Re: Comment Response to City of Portland Peer Review Engineer
Harborview Development, LLC – 121 York Street

On behalf of the project team Acorn Engineering, Inc. is pleased to respond to the comments provided by the City Peer Review Engineer dated June 23rd, 2011 by David Senus, P.E. and Ashley Auger, E.I.T. of Woodard & Curran.

1 NORTHEAST RETAINING ELEVATION
SCALE: 1/8" = 1'-0"

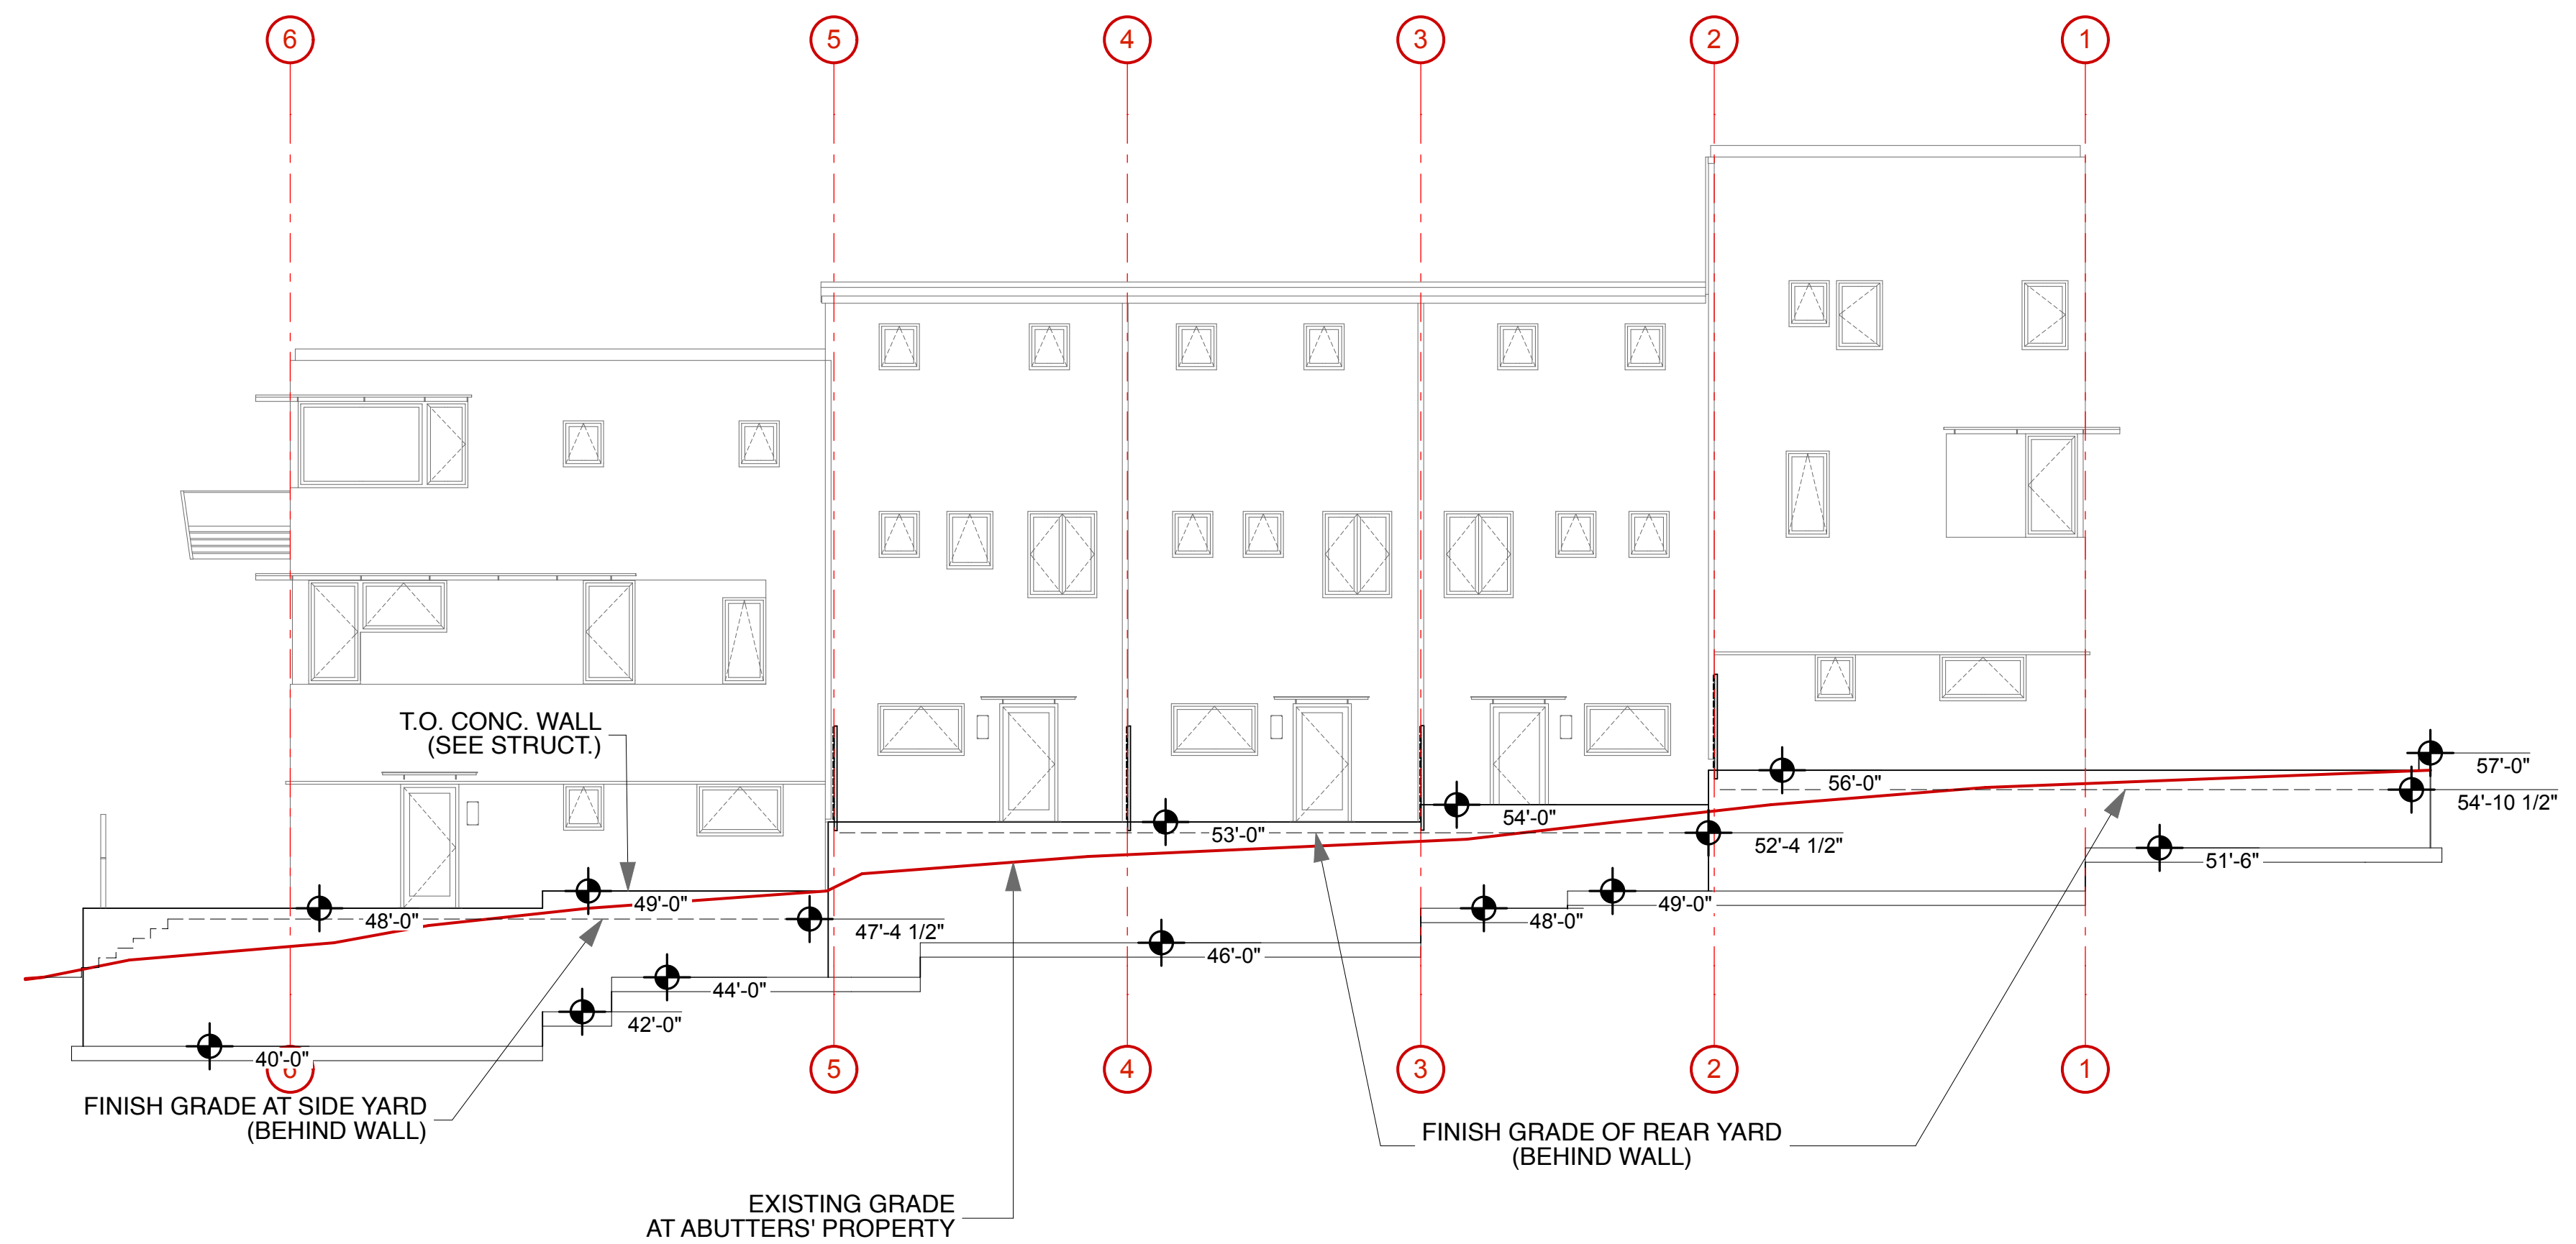
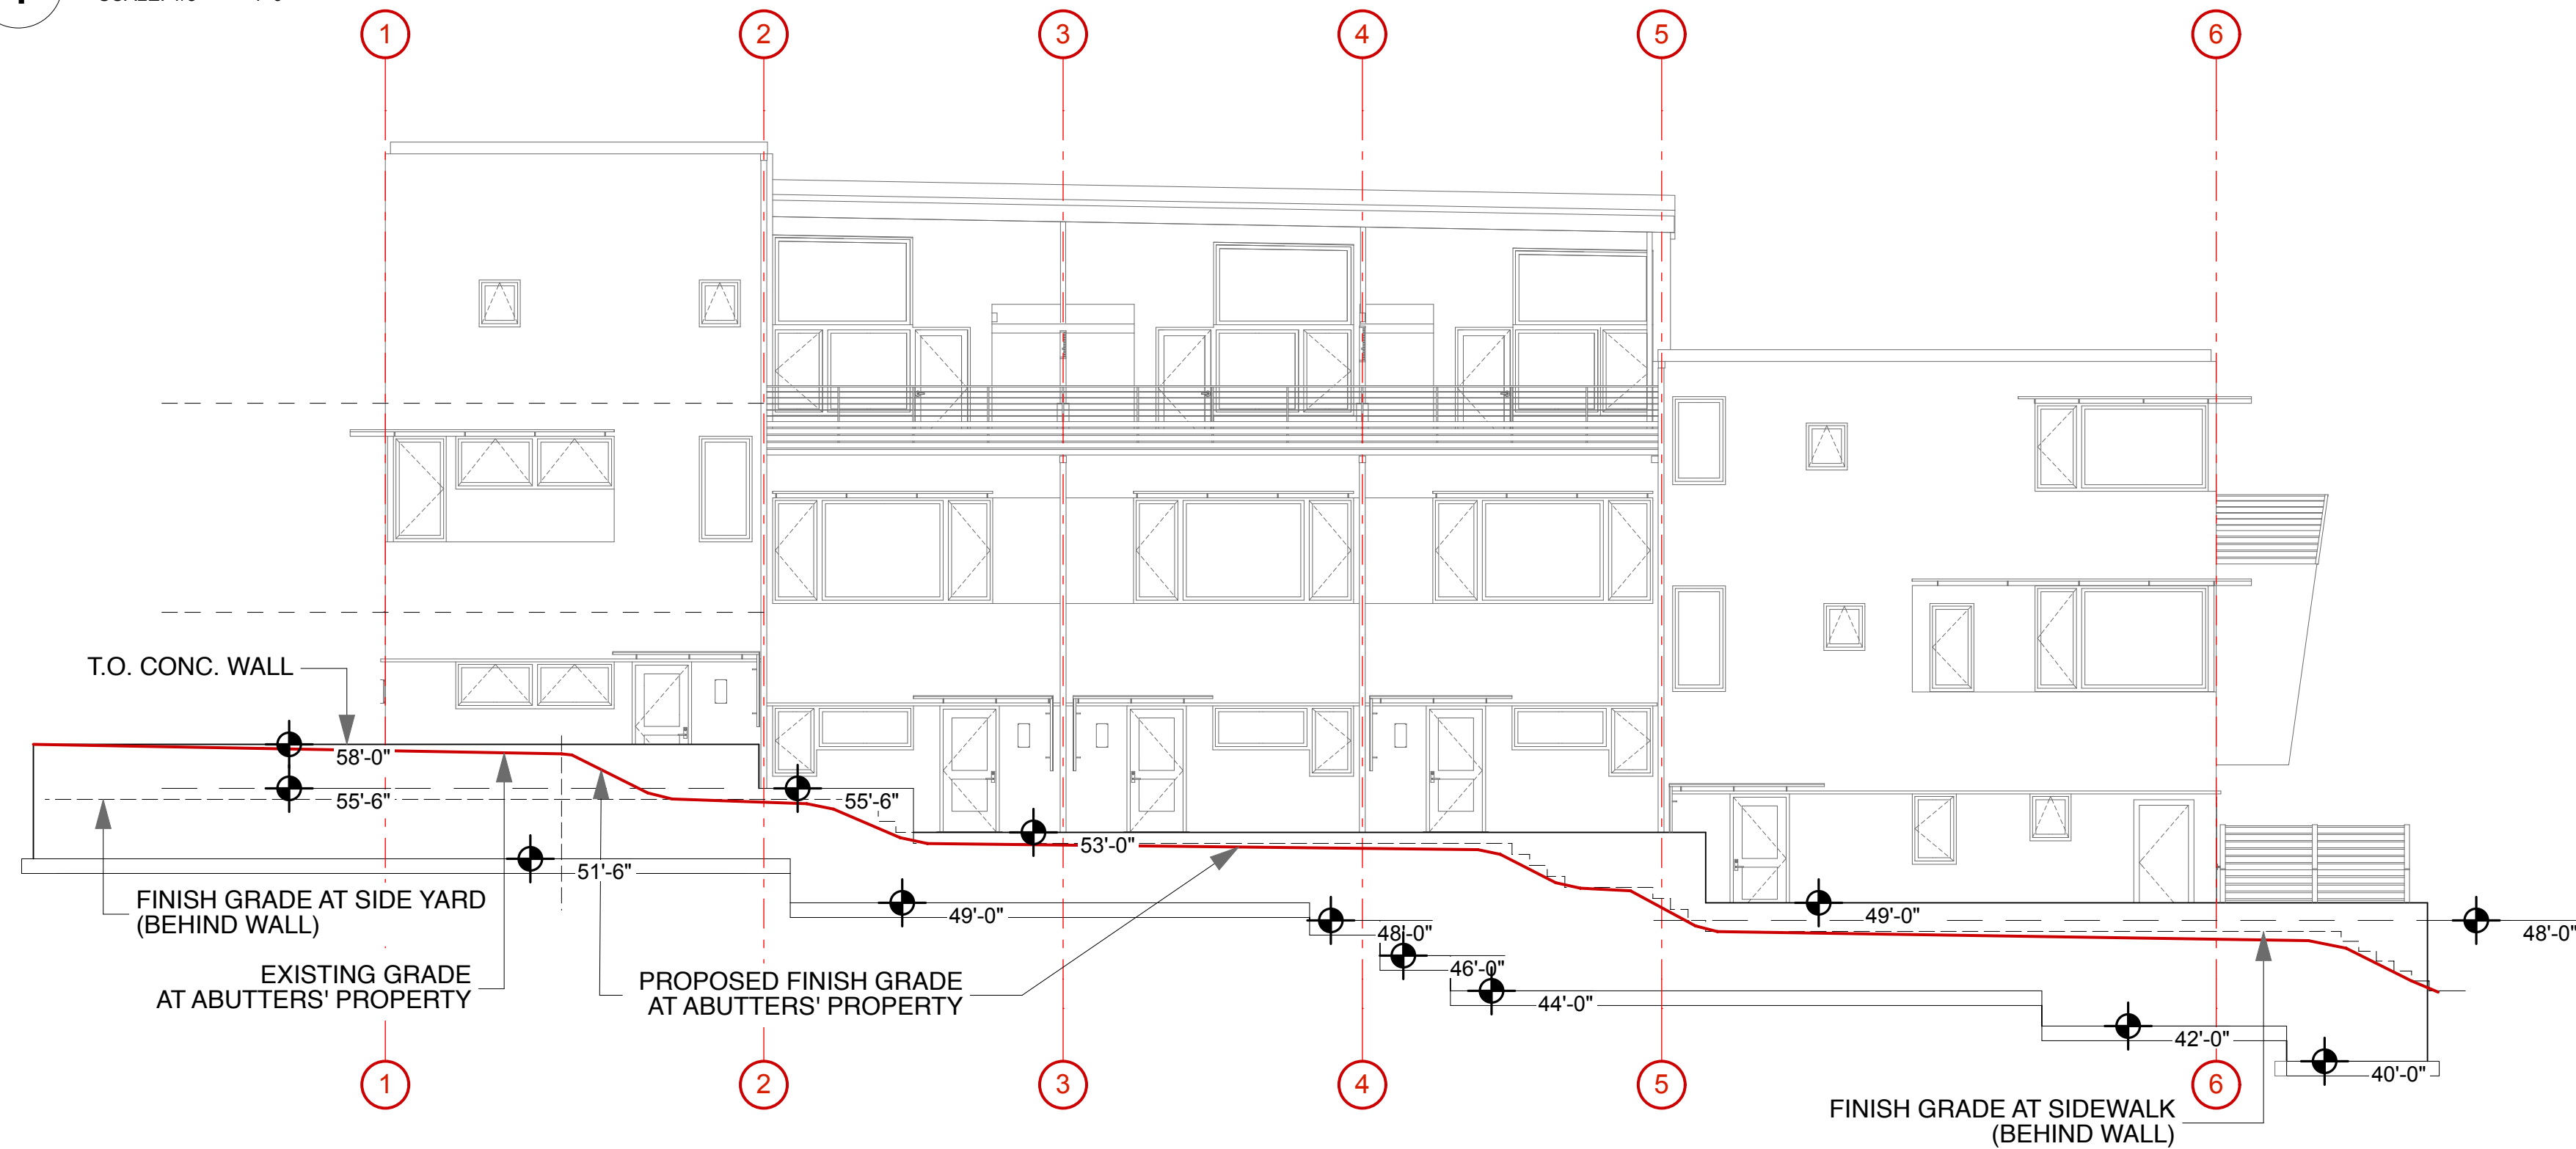
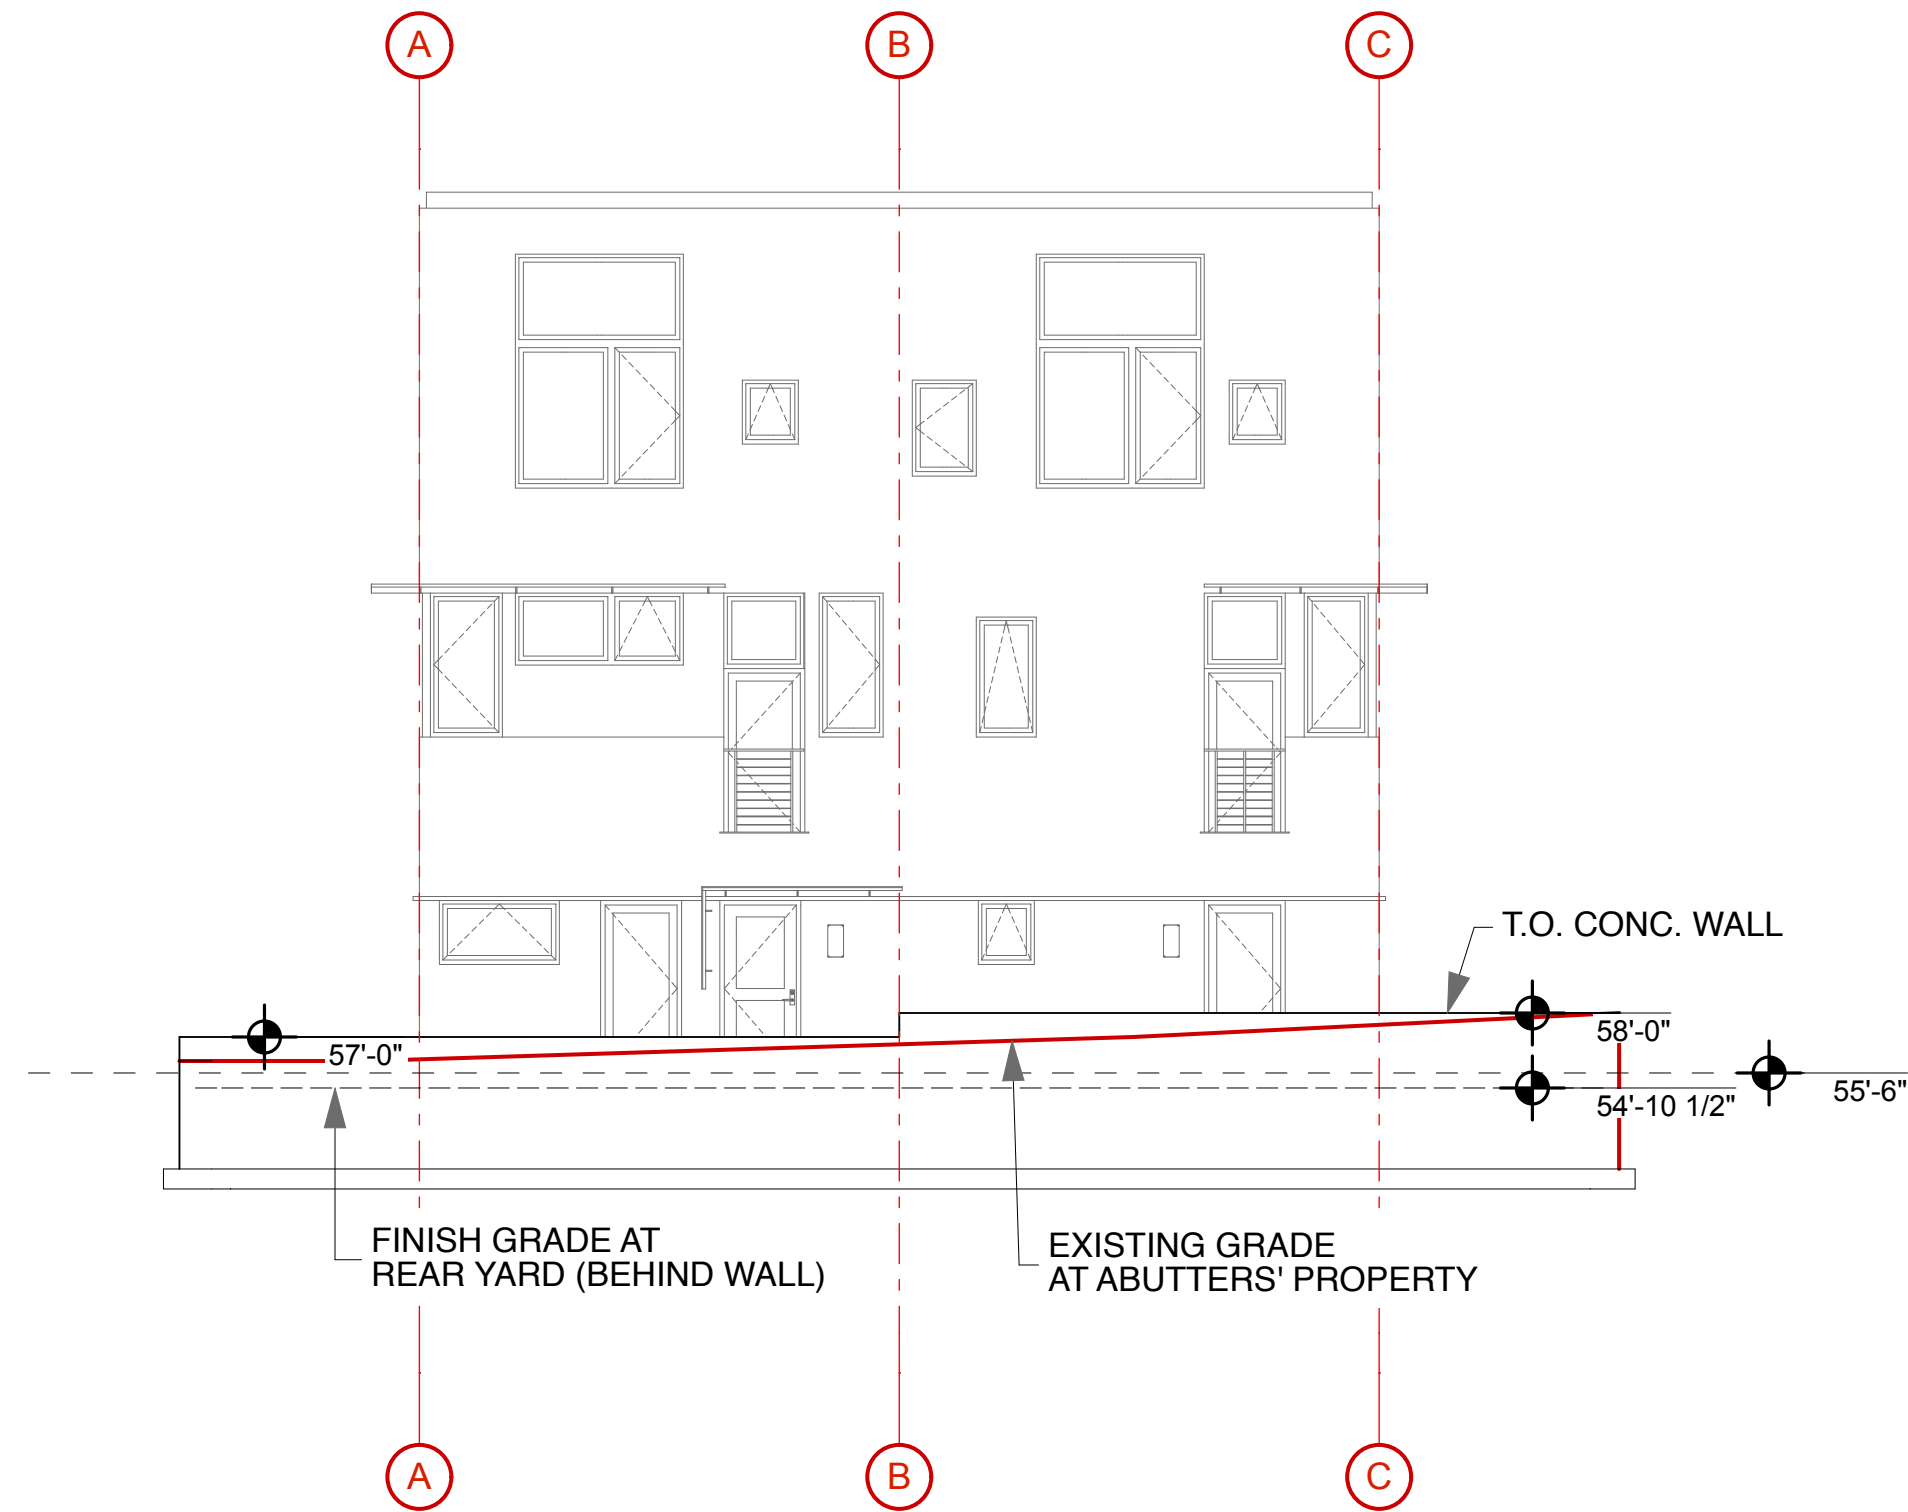
- 1. In the Applicant's response to comments letter, an explanation was provided on how the proposed grading will match into adjacent, existing conditions; however, this is not clearly presented on the most recent plans. Proposed contours along the majority of the perimeter of the property are not shown to connect to existing contours. Additional clarification is needed on the plans, especially along the eastern side of the property and the northwest portion of the parking lot.*

- Locations adjacent to the proposed building. Kaplan Thompson Architects in coordination with Casco Bay Engineering have added a perimeter retaining wall parallel to the property line. Please refer to the attached Kaplan Thompson Architect’s – Retaining Wall Elevation Plan, Northeast Retaining Elevation for the proposed retaining wall elevations and existing abutting property grades. Acorn Engineering’s Grading, Drainage, Erosion & Sed. Control Plan was updated to reflect the use of the retaining wall. Through the use of the retaining wall no offsite grading is anticipated.

- Kaplan Thompson Architects in coordination with Casco Bay Engineering have added a perimeter retaining wall parallel to the property line. Please refer to the attached Kaplan Thompson Architect’s – Retaining Wall Elevation Plan, Northwest Retaining Elevation for the proposed retaining wall elevations and existing abutting property grades. Acorn Engineering’s Grading, Drainage, Erosion & Sed. Control Plan was updated to reflect the use of the retaining wall. Through the use of the retaining wall no offsite grading is anticipated.

- Locations adjacent to the proposed building. Kaplan Thompson Architects in coordination with Casco Bay Engineering have added a perimeter retaining wall parallel to the property line. Please refer to the attached Kaplan Thompson Architect’s – Retaining Wall Elevation Plan, Southwest Retaining Elevation for the proposed retaining wall elevations and proposed abutting property grades. Acorn Engineering’s Grading, Drainage, Erosion & Sed. Control Plan was updated to reflect the use of the retaining wall. It is anticipated that offsite grading will be necessary adjacent to McCormick Place. Please see response 2 below regarding abutting property easements.
